**TOWN OF ERIE
PLANNING COMMISSION MEETING
May 15, 2019**

SUBJECT: **Agenda # 19-239**

Review of the Canyon Creek Filing No. 7 & 8 Sketch Plan

PURPOSE: Review and comment on a Sketch Plan application for 109 single-family lots and 88 duplex lots.

Below, with the site outlined in a red dashed line, is the Future Land Use Plan Map from the Comprehensive Plan:

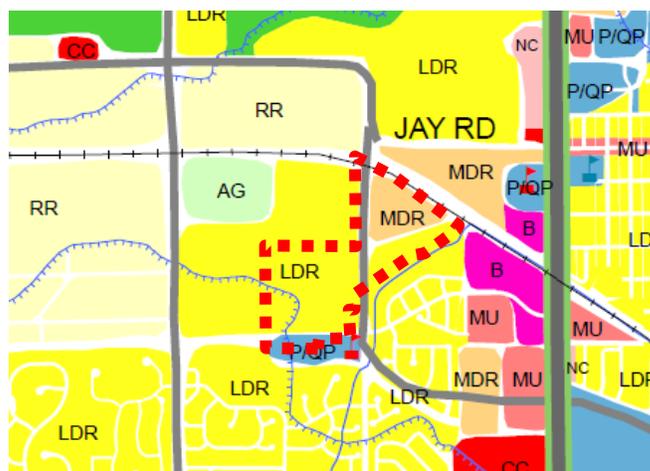
The majority of the property is designated as LDR – Low Density Residential (2-6 du/ac) on the Comprehensive Plan, Land Use Plan Map. An area of Filing 8 is also designated as MDR – Medium Density Residential (6-12 du/ac). LDR areas will primarily be suburban-style developments; however, the designation allows for a range of single-family detached and attached homes, townhomes, patio homes, and in appropriate cases include complementary neighborhood-scale supporting land uses, such as retail, commercial, and office uses in a neighborhood setting. MDR areas should incorporate a mix of housing types and recognizable community centers such as park, recreation, and neighborhood or community commercial areas in a neighborhood setting. The submitted Sketch Plan meets the intent of LDR and MDR per the characteristics, as the Sketch Plan proposes developing the site as single-family residential in Filing 7 (2.92 du/ac) and duplex residential in Filing 8 (6 du/ac).
